TITLE OUTLINE MOTOR
DRAWN: JAF 06.03.11
APPR:
DEPT:
SCALE: -

DESCRIPTION
MOTOR, BRUSHLESS, 36V, PM

PART OR ASSY. #	REV	SCALE	SHEET #
MP203300	C	NONE	1 of 1

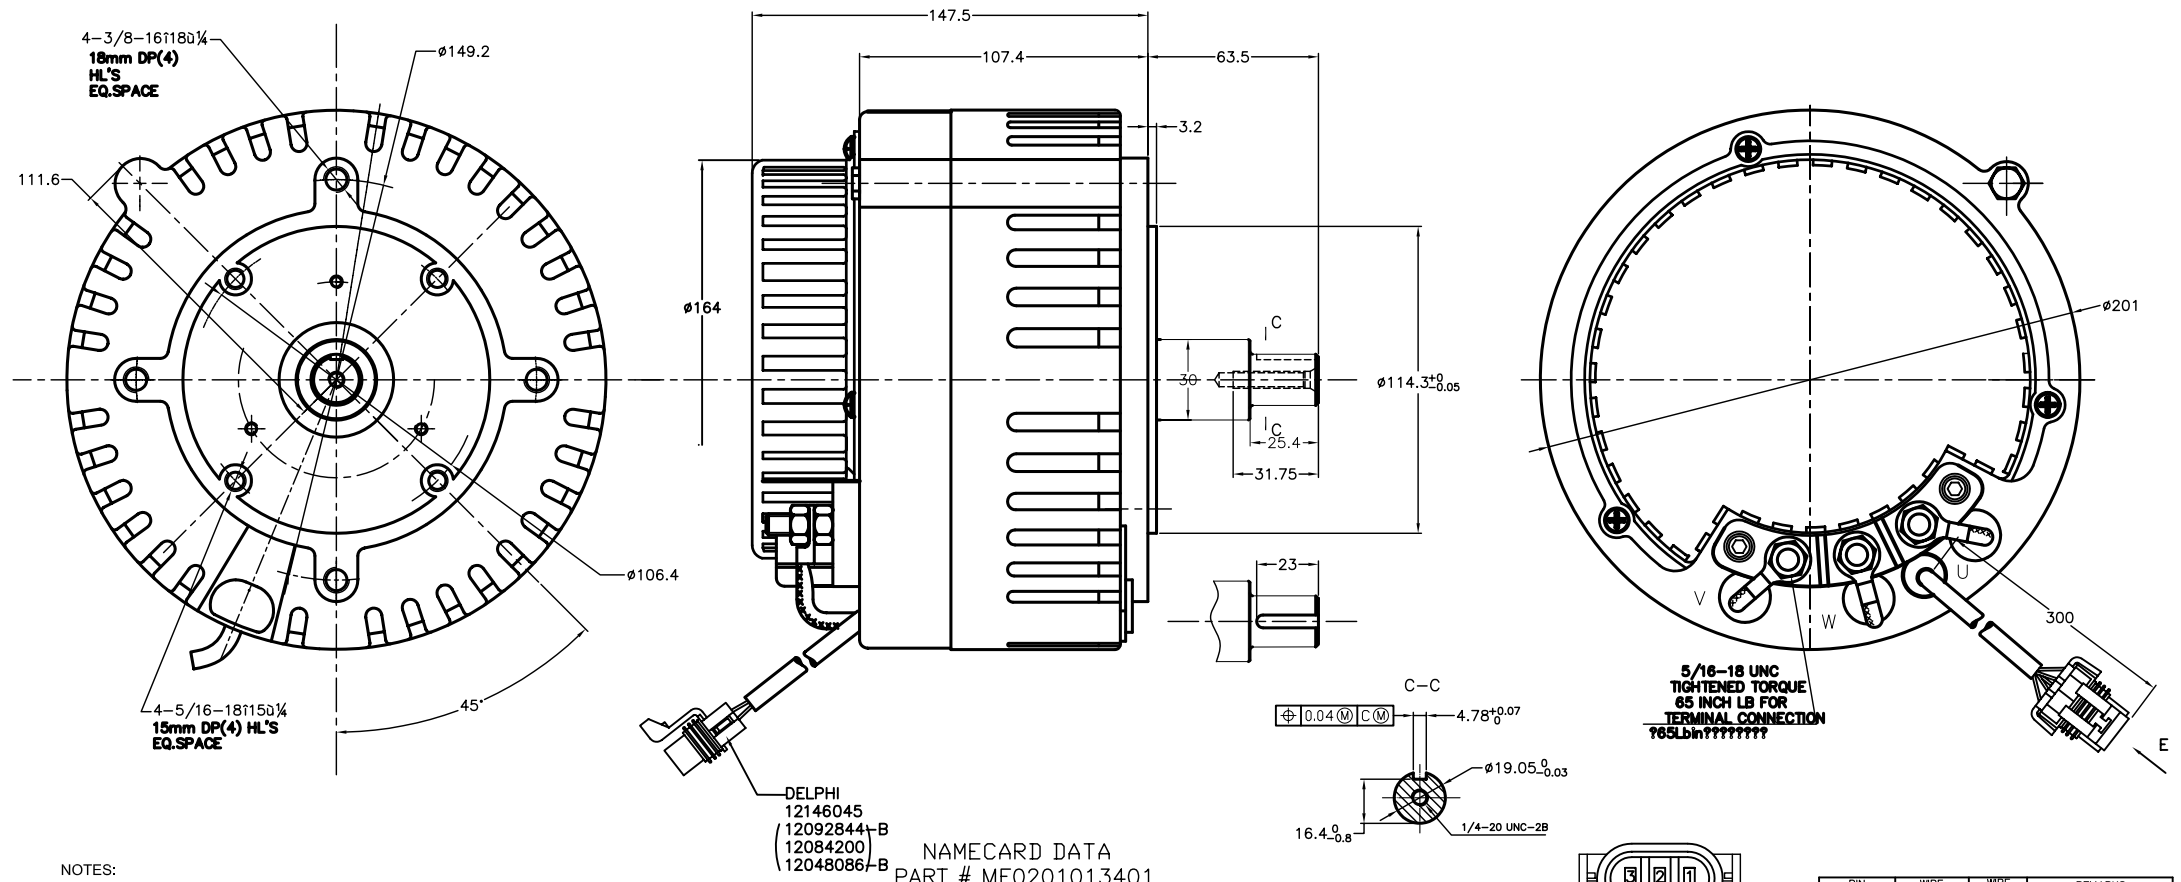
ZONE	REV LEVEL	REVISIONS	ECN	REV DRAWN	REV CHECK	APPROVED BY/DATE
–	A –	INITIAL ISSUE	05-0037-1			
B4 B6	B –	CHANGED KEY WAY DEPTH, WAS 17.1mm CHANGED WIRING CONNECTOR	05-0162-1	MSP	GLB	PRK 11/3/05
	C –	CHANGED MOTOR TO A 20 TURN, WAS 24 TURN. VENDOR # IS ME0201013401, WAS ME0201013101.	06-0048-1	MSP
